**PROPOSED GREEN FUEL STATION (ELECTRIC VEHICLE CHARGING) AND SHOP AND  
SERVICES (CONVENIENCE STORE) AT WORKSHOPS 7 & 8 ON GROUND FLOOR,  
METRO CENTRE, 32 LAM HING STREET, KOWLOON BAY, KOWLOON**

**Planning Application No. A/K13/334 – Further Information (5)**

**Consolidated Report**

**Attachment 1: Response-to-Comment Table (Departmental Comments)**

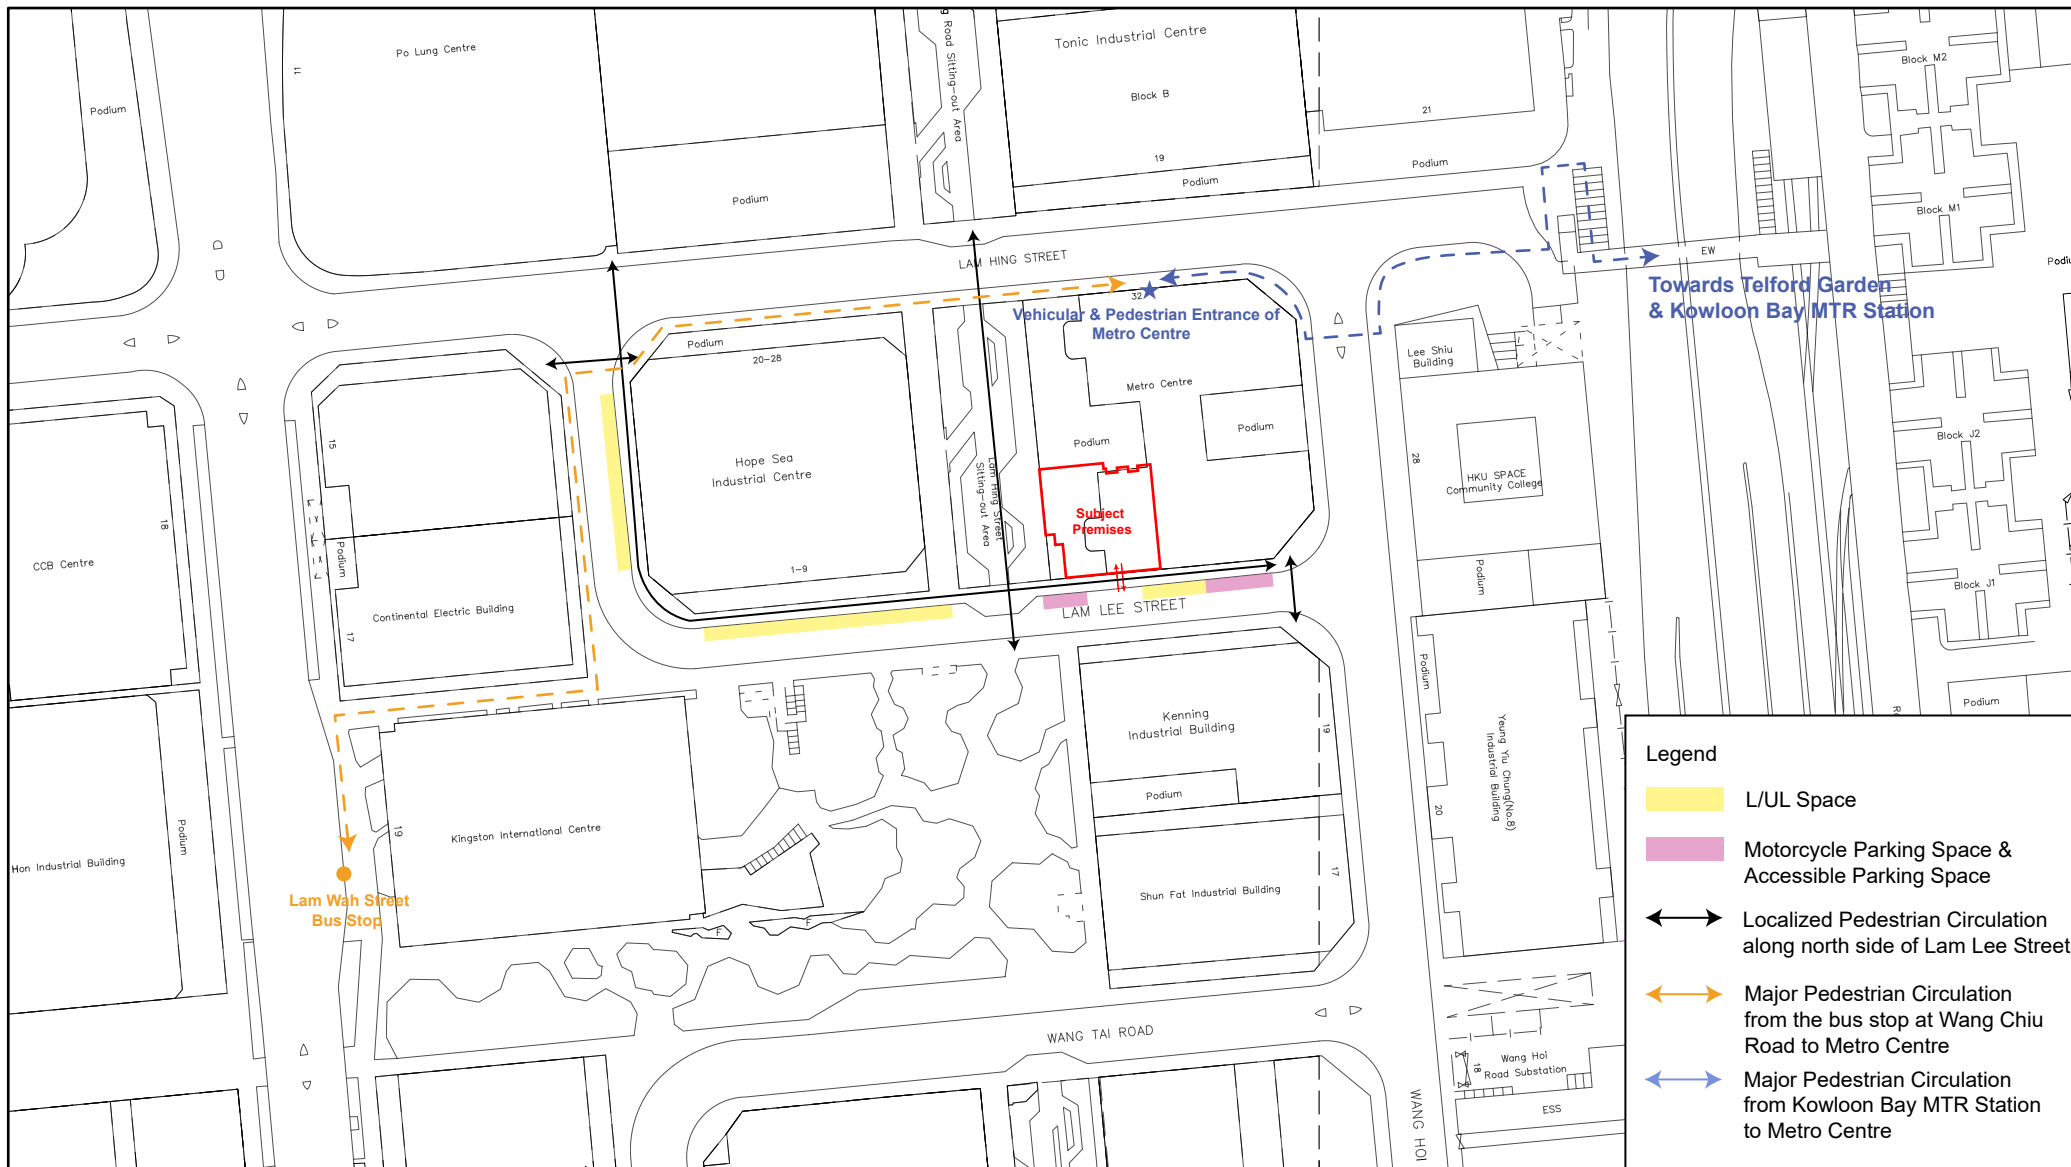
| <i>Departmental Comments</i>                                                                                                                                                                                                                                                                                                                                                                                                                                                                                                                                                                                                                                                                                                                                                                                                                                                                                                                                                                                                                                                        | <i>Response</i>                                                                                                                                               |
|-------------------------------------------------------------------------------------------------------------------------------------------------------------------------------------------------------------------------------------------------------------------------------------------------------------------------------------------------------------------------------------------------------------------------------------------------------------------------------------------------------------------------------------------------------------------------------------------------------------------------------------------------------------------------------------------------------------------------------------------------------------------------------------------------------------------------------------------------------------------------------------------------------------------------------------------------------------------------------------------------------------------------------------------------------------------------------------|---------------------------------------------------------------------------------------------------------------------------------------------------------------|
| 1. As referring to Figure 6 in the revised traffic review report, the Applicant is requested to review the appropriateness of using the traffic sign (TS461) "pedestrian crossing ahead" in accordance with the relevant TPDM requirements as there is no designated crossing thereat. Applicant may consider providing other appropriate measure(s) to alert motorists to pay attention about pedestrians crossing the proposed run-in/out or vice versa.                                                                                                                                                                                                                                                                                                                                                                                                                                                                                                                                                                                                                          | Noted. The Applicant has revised the relevant measures to ensure pedestrian safety. Please refer to the <b>Appendix 1 of Attachment 2</b> for your reference. |
